City of Albuquerque

**Re: Santa Fe Village Subdivision Drainage Report
Engineer's Stamp dated 12-17-02 (F10/D6A)**

DRAINAGE REPORT

Santa Fe Village

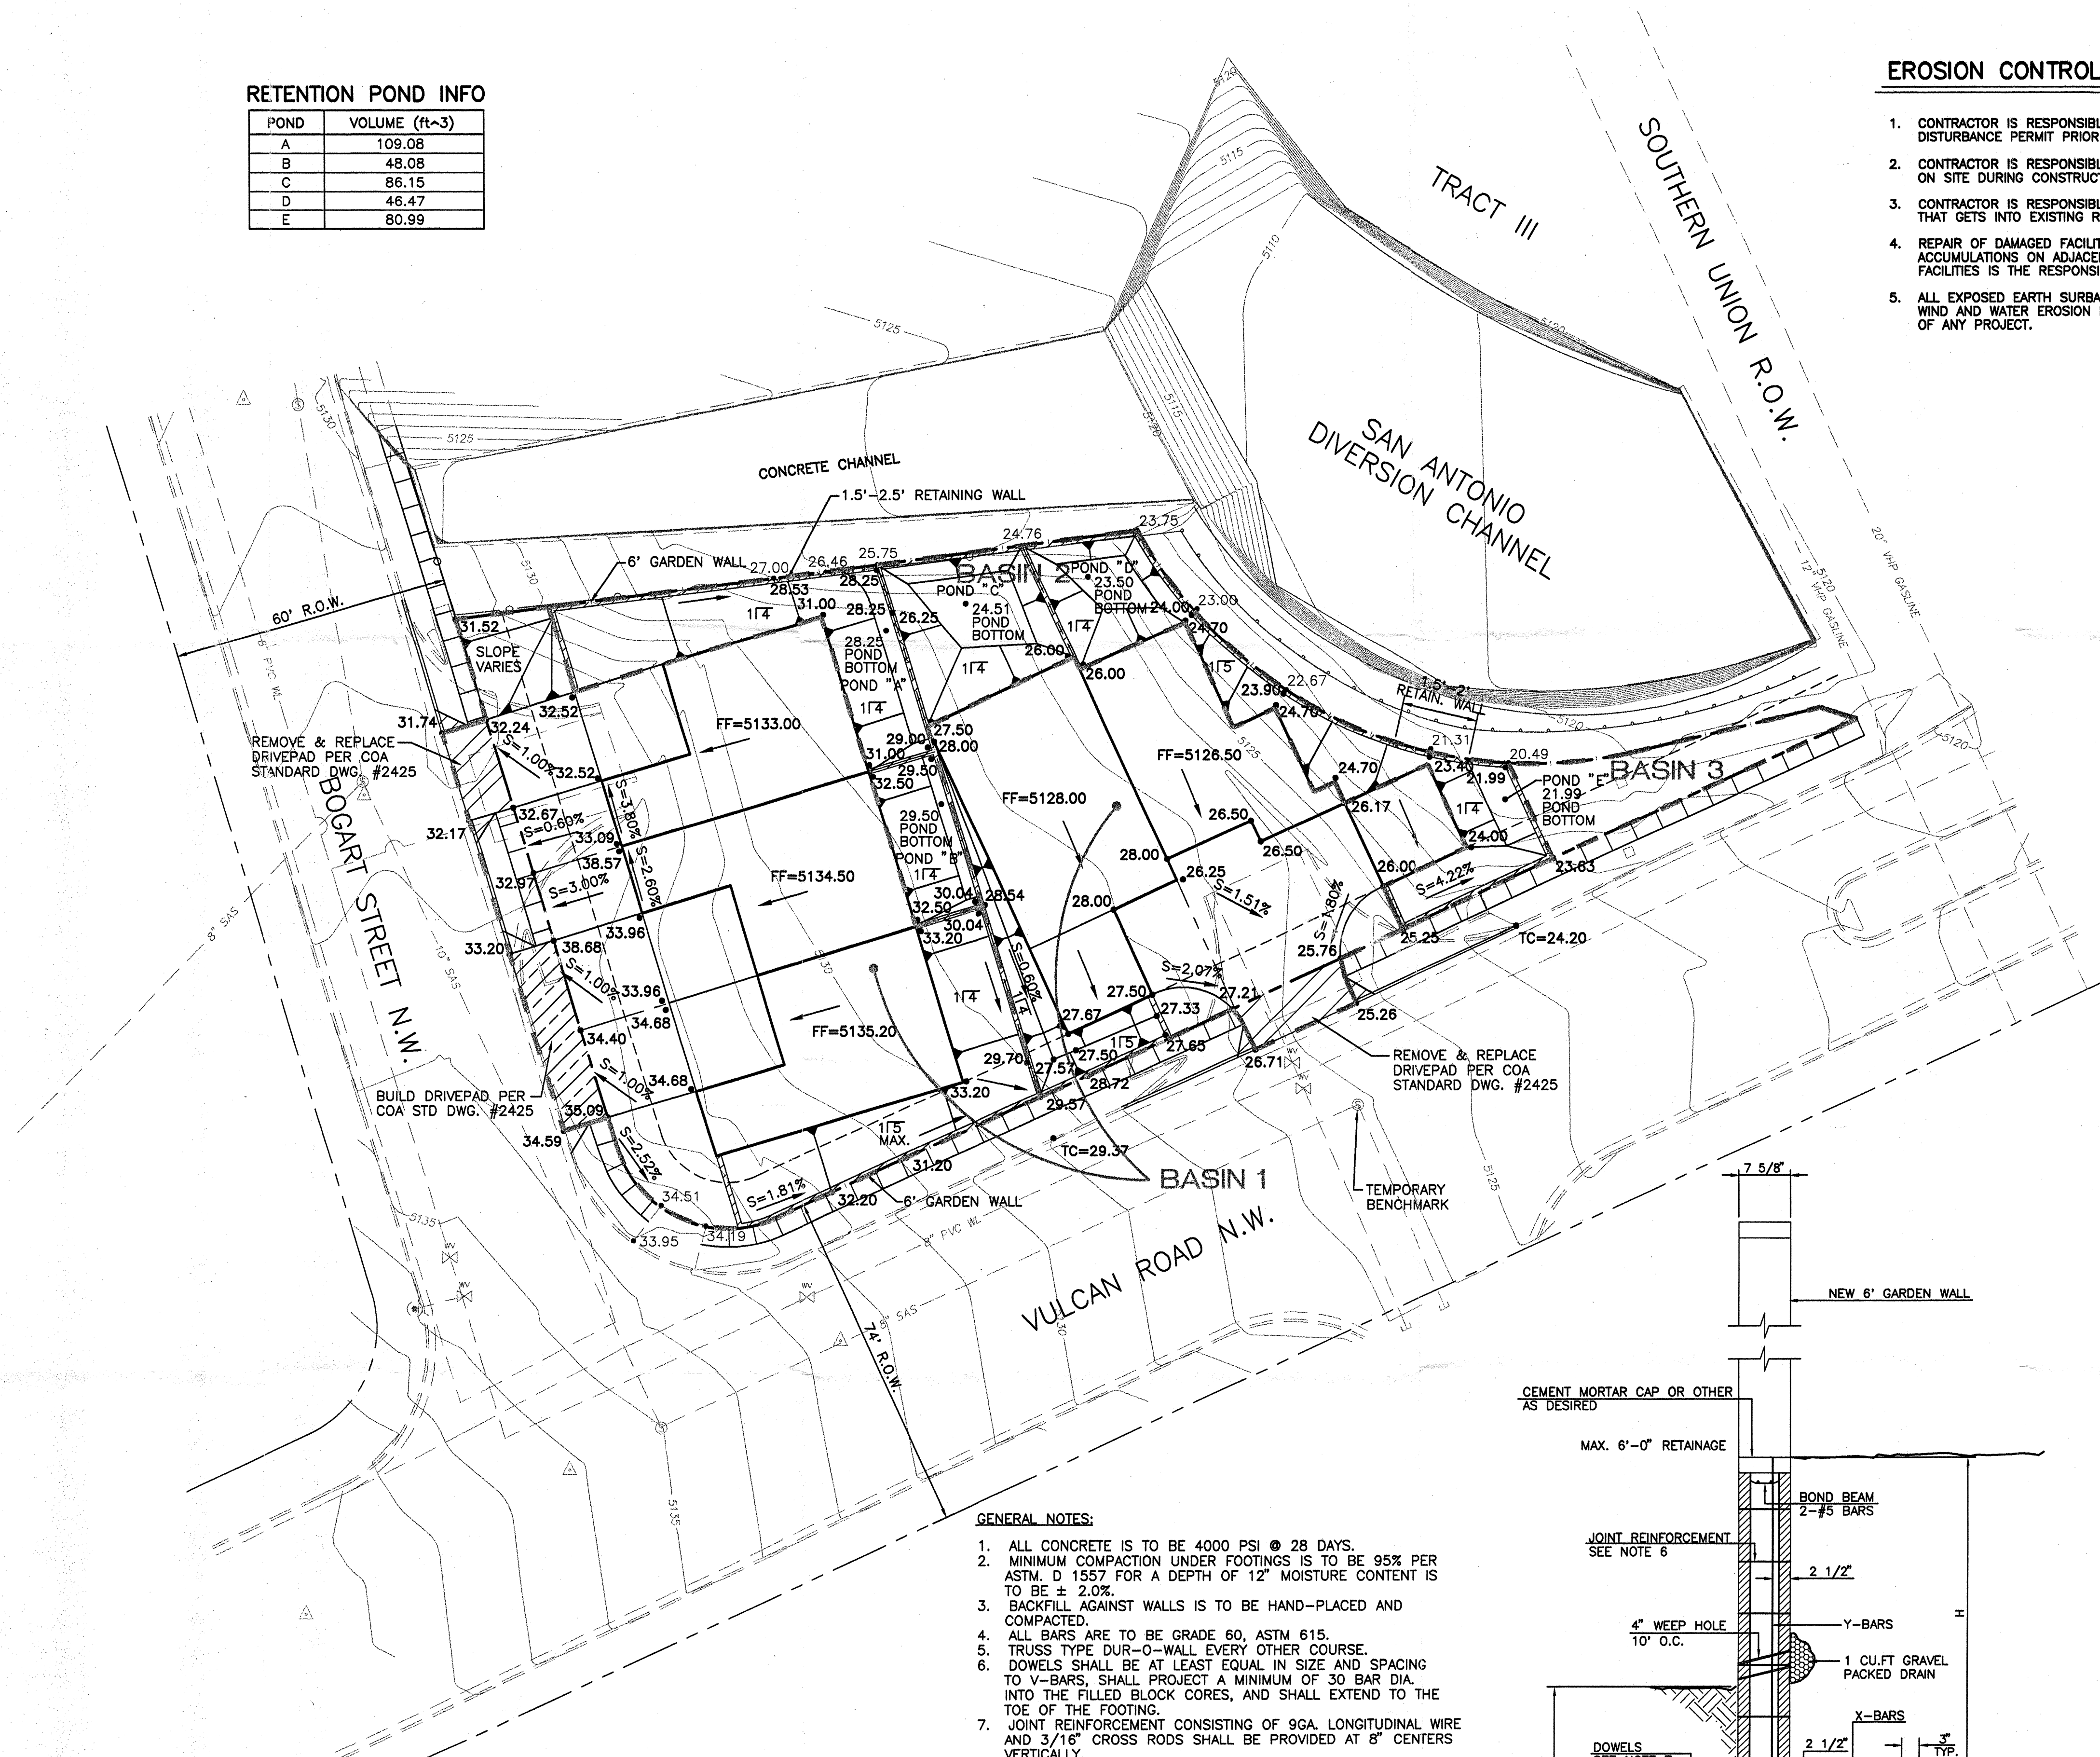
Please be advised that the concrete rundown channel into the San Antonio arroyo must be constructed under Work Order. Work order plans must be approved prior to Building Permit release. This drainage structure must be certified with the grading and drainage prior to release of the Certificate of Occupancy.

DRAINAGE PLAN (REVISED) FOR
SANTA FE VILLAGE UNIT III - COMMERCIAL AREA
ALBUQUERQUE, NEW MEXICO

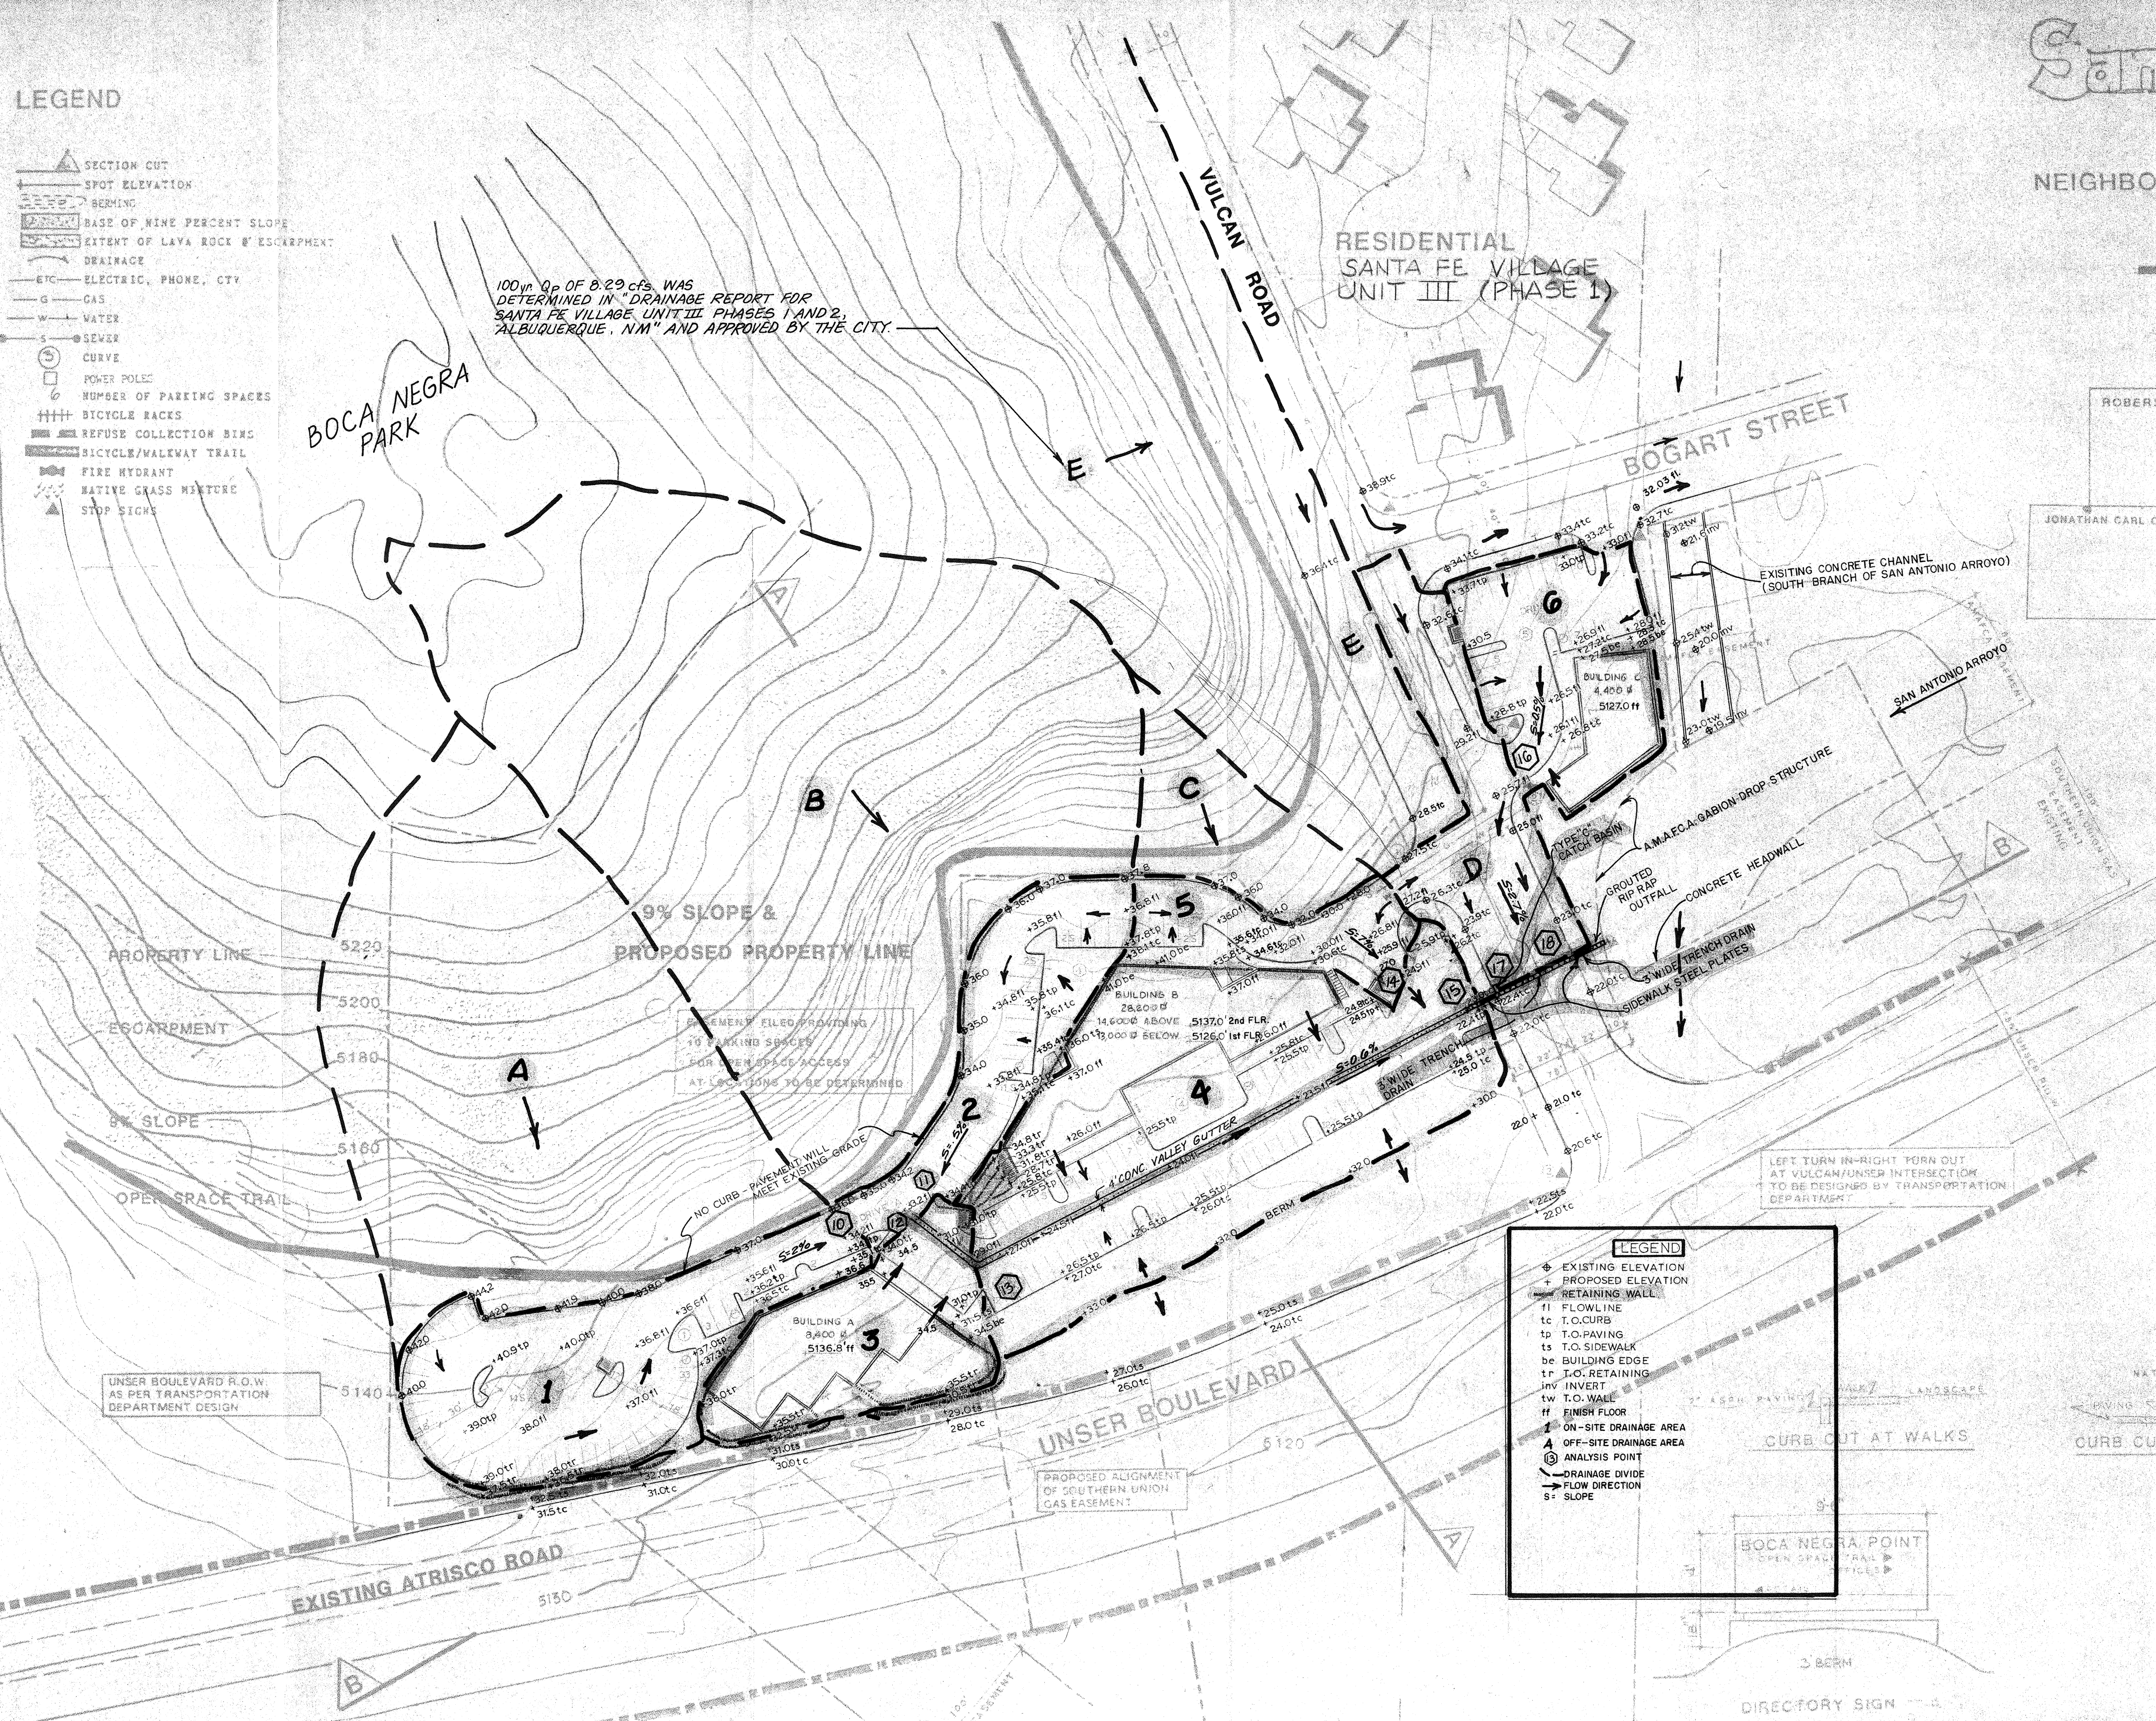
1. a breakdown of on-site area 4 land treatment to
justify using a "C" value of 0.77 and RCN of 77.
2. detailed large scale drainage and grading plans for
each building site.
